ADDENDUM #4

BID No. 22-115-3320

For: Gilbert Road Water Tank Improvements

#2507

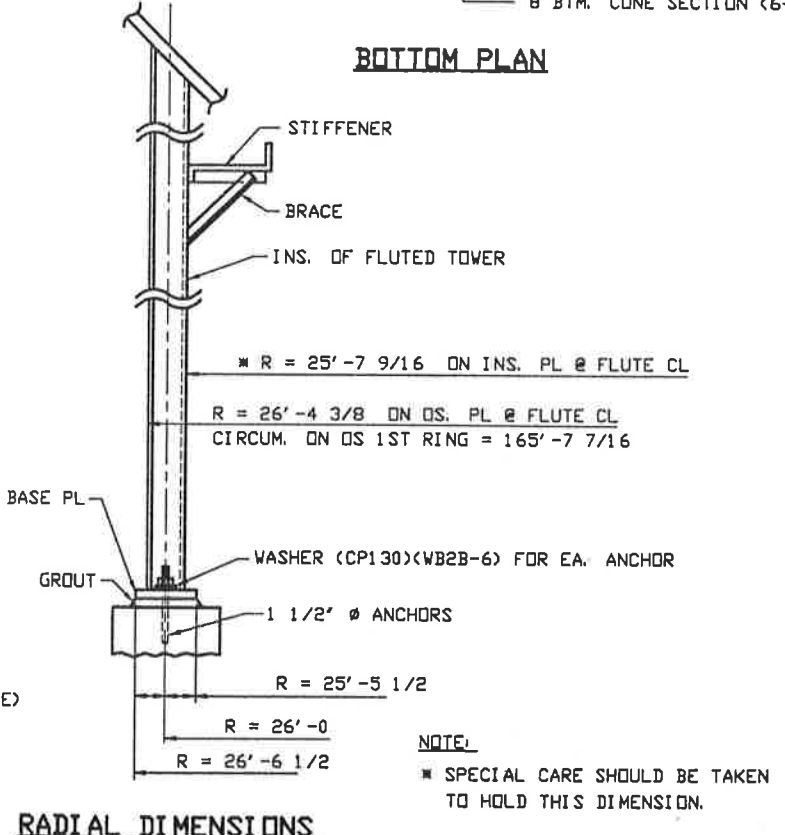
21.Q: See picture number 2507 which is attached (below). Please confirm the county will work with the power company to get the lines dropped/moved. The power company will work with the county more so than a contractor they don't know.

A: Forsyth County will assist the Contractor in getting the power lines de-energized, as needed.

#9007

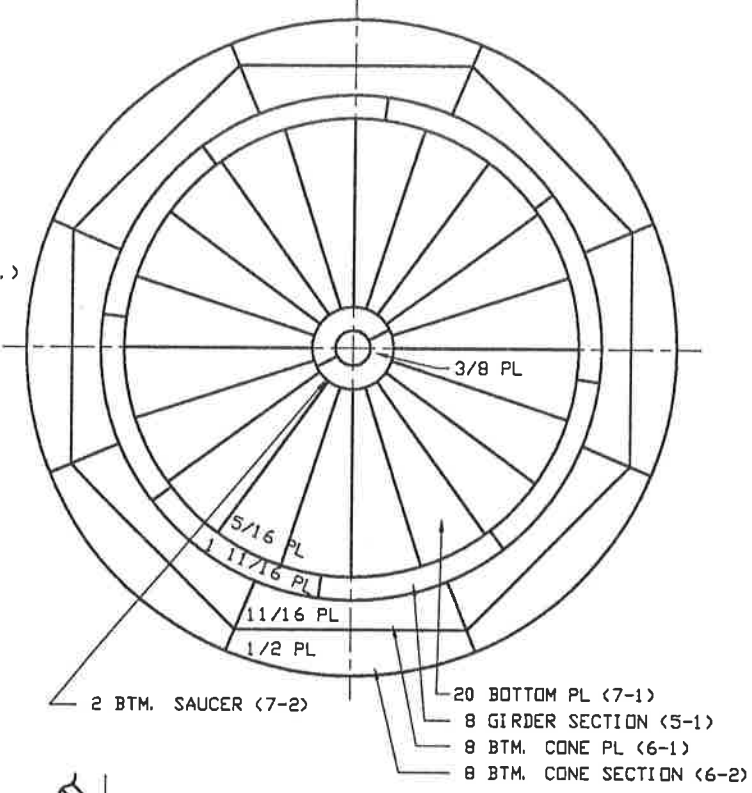
26.Q: Dust is likely to get on the interior dry from sandblasting. Please confirm the generator will be relocated until the project is completed. See picture 9007 which is attached (below).

A: Forsyth County will remove the emergency generator from the site prior to Notice to Proceed.

#2894

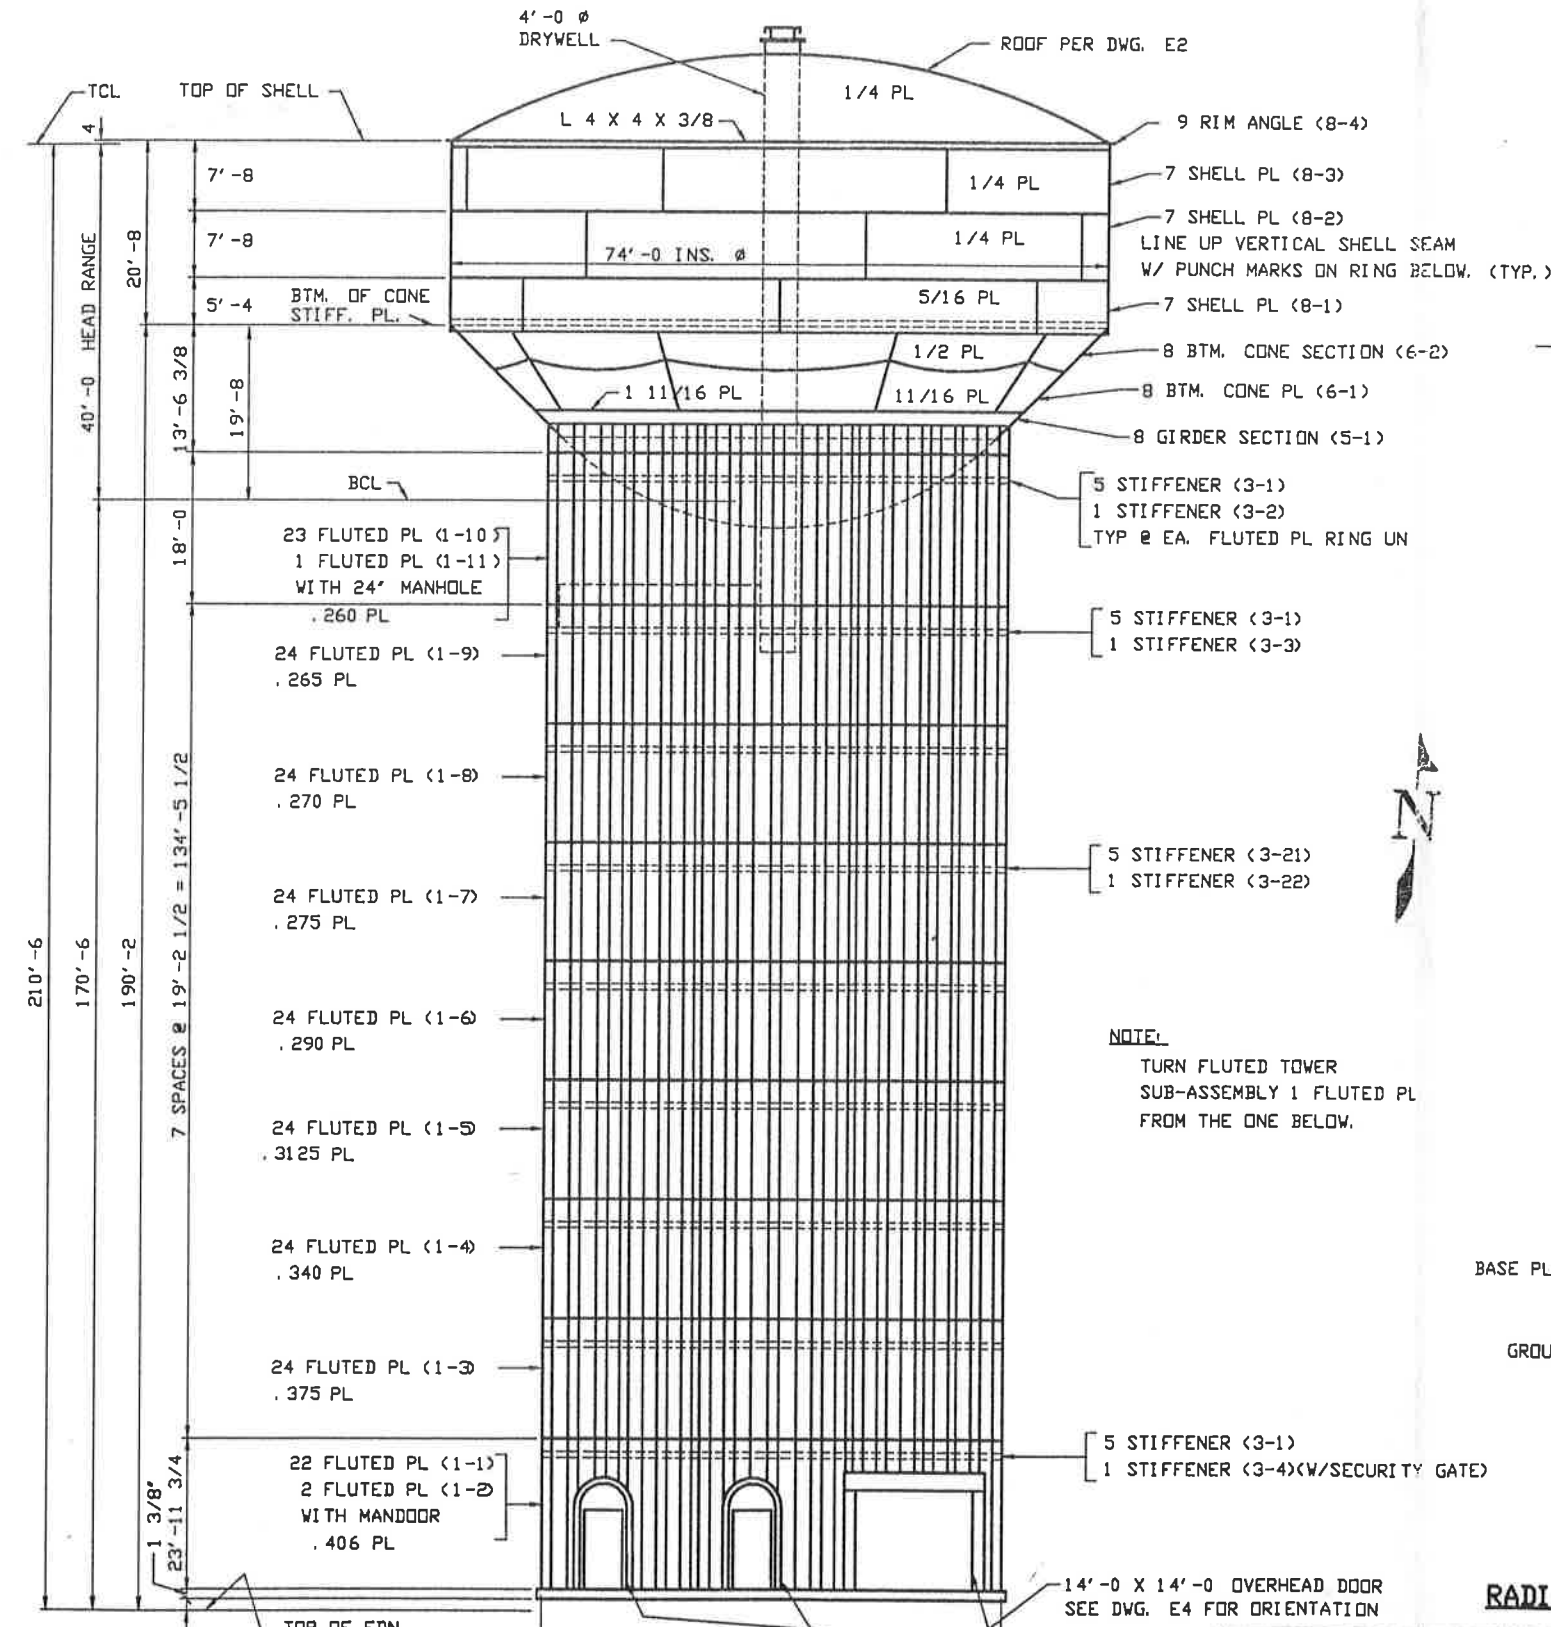
27.Q: Was the exterior of this tank painted last with a clear coat? Picture 2894 (below) shows the coating still has good gloss. If it was painted with a clear coat, the surface prep needs to be NACE WJ-4 with grit injection to etch the clear coat.

A: The tank is not known to have a clear coat applied to the exterior.
